CARBON CAPTURE AND SEQUESTRATION PROTOCOL UNDER THE LOW CARBON FUEL STANDARD

Carbon Capture and Sequestration Protocol under the Low Carbon Fuel Standard

August 13, 2018

Deletions and additions to the originally proposed Carbon Capture and Sequestration Protocol under the Low Carbon Fuel Standard (published on March 6, 2018 as Appendix B to the Initial Statement of Reasons) that were made public with the “Notice of Public Availability of Modified Text and Availability of Additional Documents and Information” are shown in ~~strikethrough~~ and underline tracked changes format, respectively. New deletions and additions that are made public with the “Second Notice of Public Availability of Modified Text and Availability of Additional Documents and Information” are shown in ~~highlighted strikethrough~~ and underline tracked changes format, respectively

Figure 1. System boundary for CO₂ capture and sequestration in oil and gas reservoirs used for CO₂-EOR.

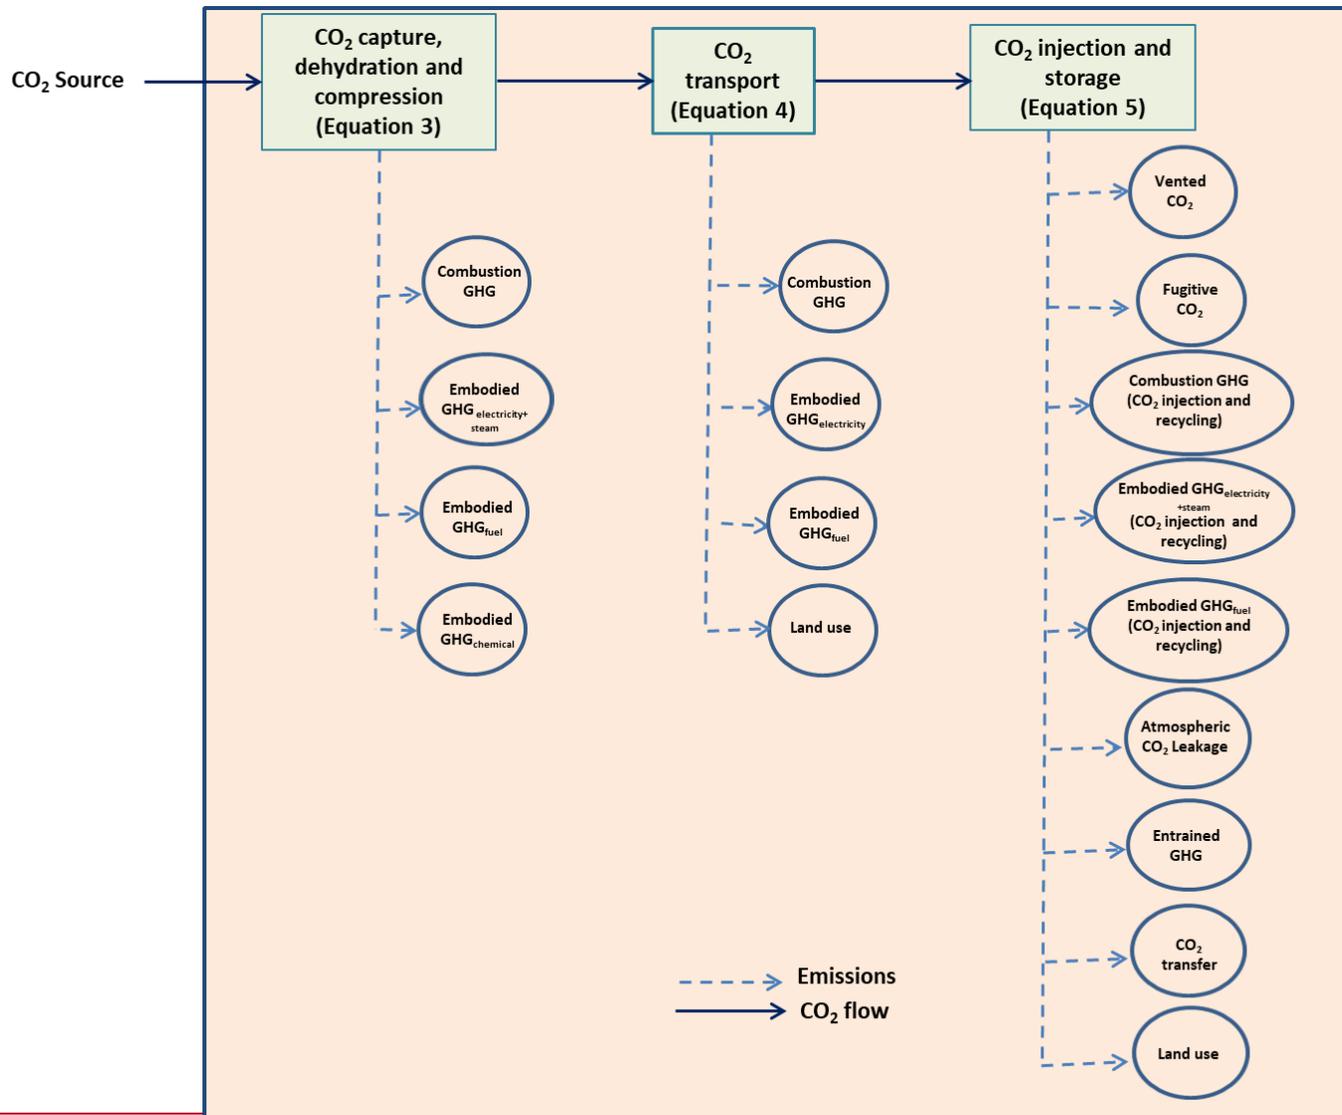
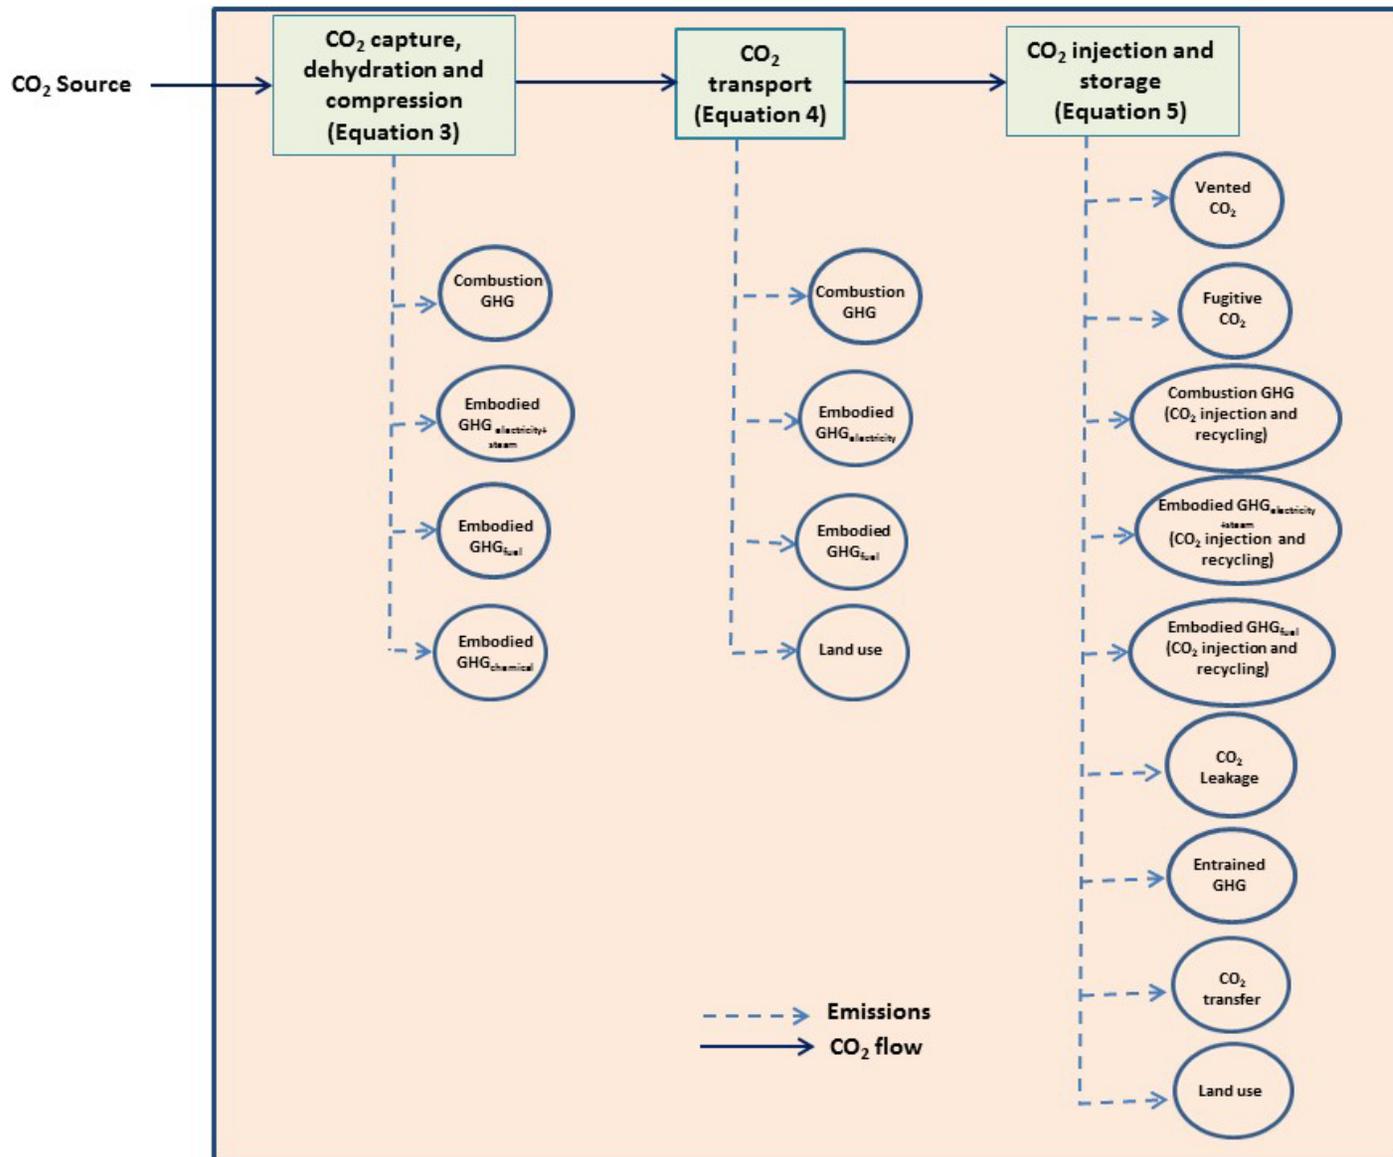
The specific types of equipment and sources covered by the system boundary can vary by CCS project types. Figure 12 shows the system boundary for capturing CO₂ and sequestering it in oil and gas reservoirs used for CO₂-EOR indicating which SSRs are included. ~~Likewise, Figure 23 shows the system boundary for capturing CO₂ and sequestering it in depleted oil and gas reservoirs and saline formations.~~
